REQUEST FOR INFORMATION

Hope Bay Mining Project

Subject:	North Dam – Frozen Core Construction	Project Zone/Area:	Doris North Project
Company:	SRK Consulting (Canada) Inc.	Station/Location:	North Dam Sta. 0+70 to Sta. 1+20
Attention:	Lowell Wade	Discipline:	Civil

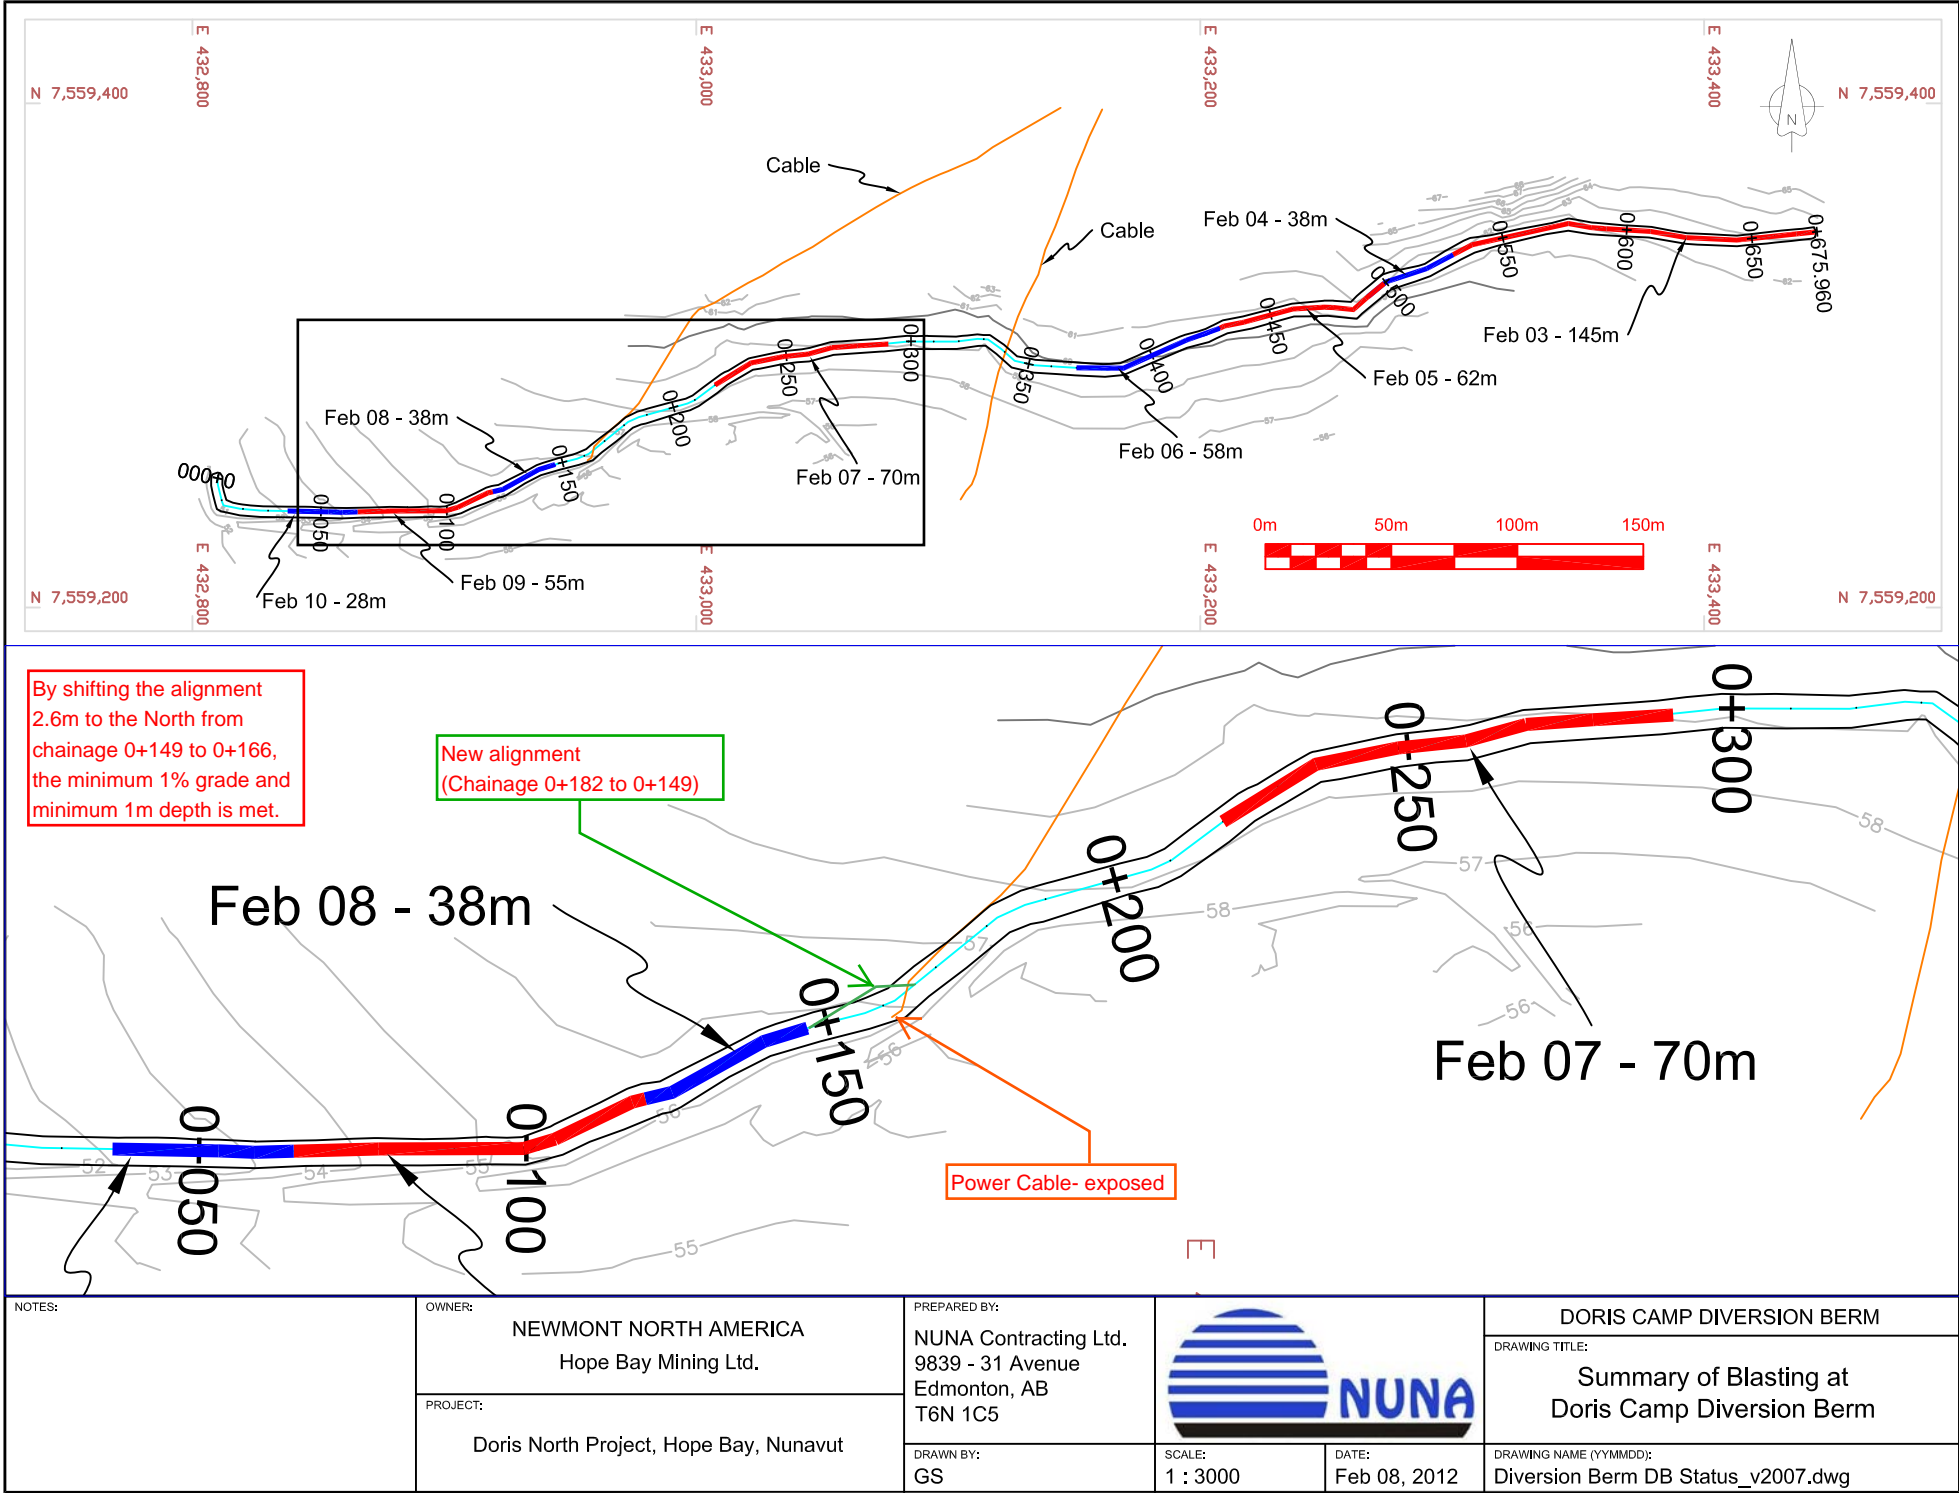
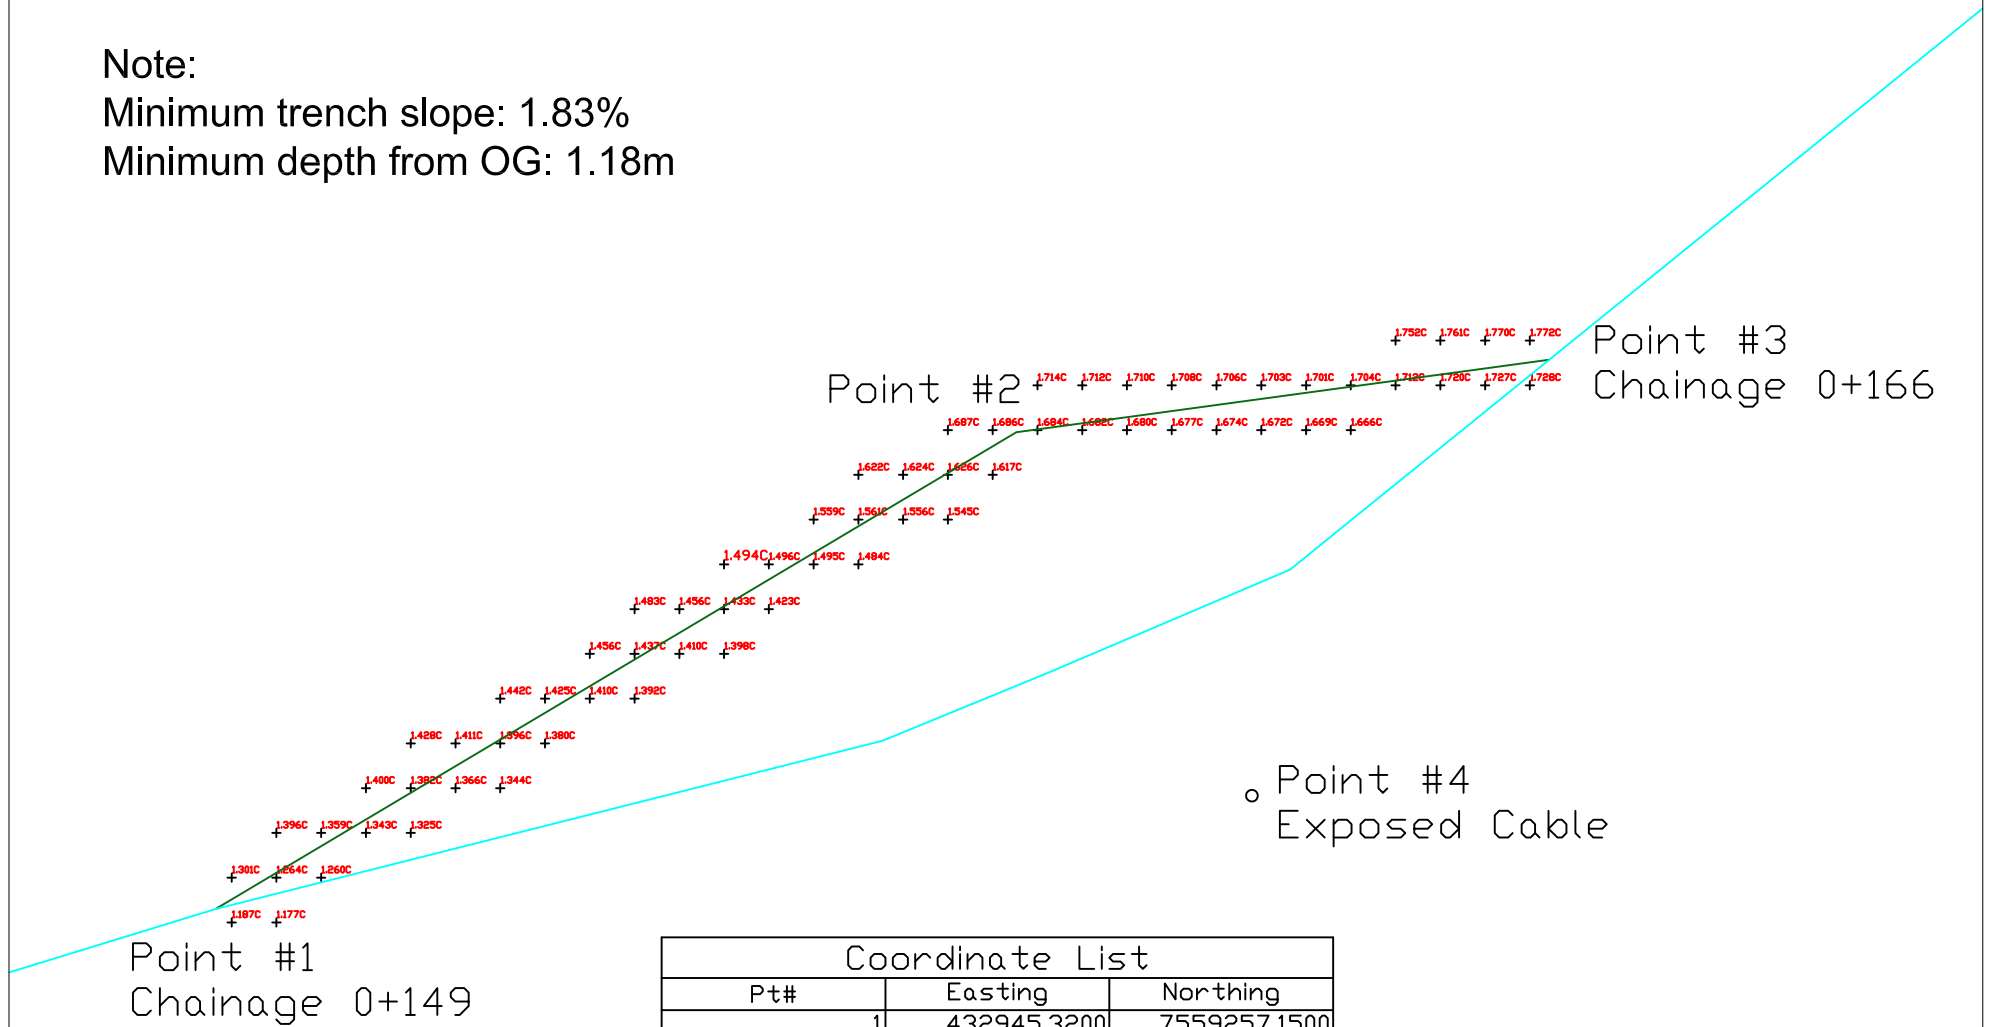
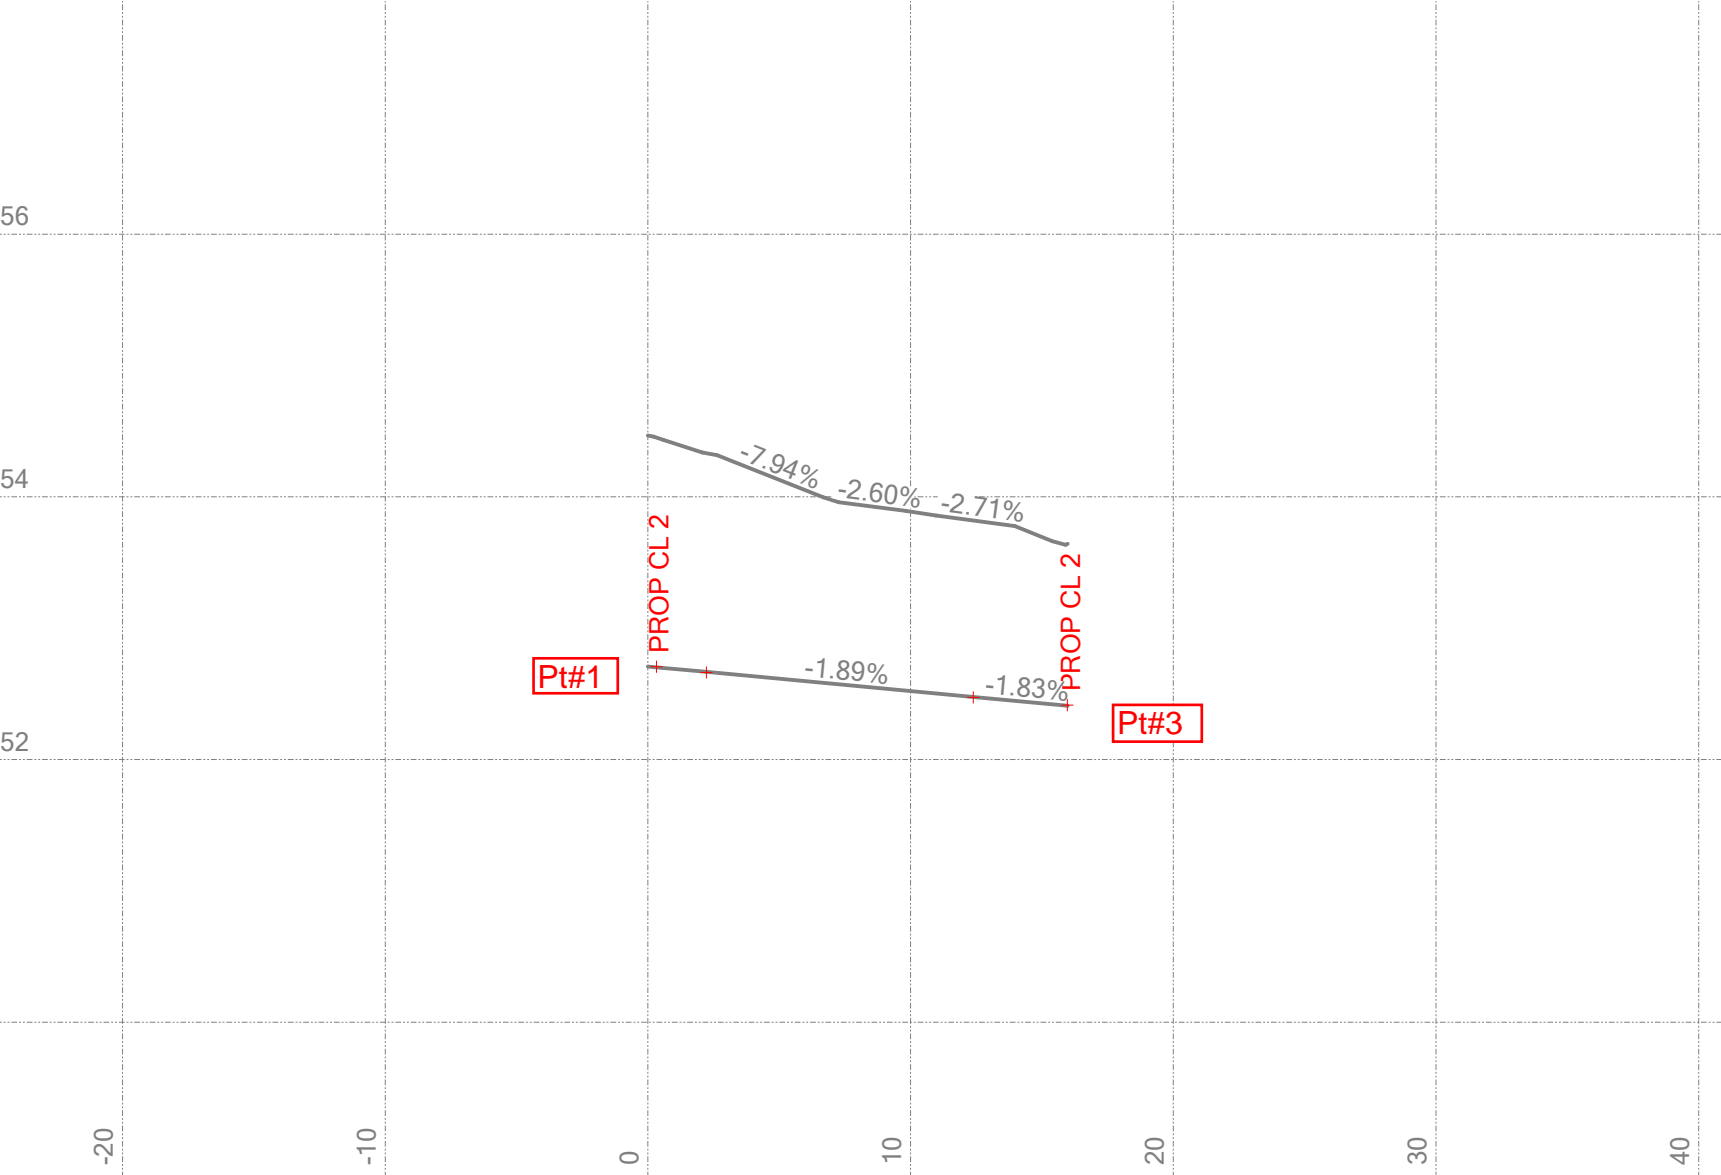
Minimum trench slope: 1.83%

Minimum depth from OG: 1.18m

SRK agrees with the proposed solution to permit drilling and blasting of this section of trench provided all design criteria for the water diversion berm have been satisfied. Slight adjustments up the upstream toe of the ROQ cover, over the trench, may be required to ensure there is no ponding of water on the tundra.
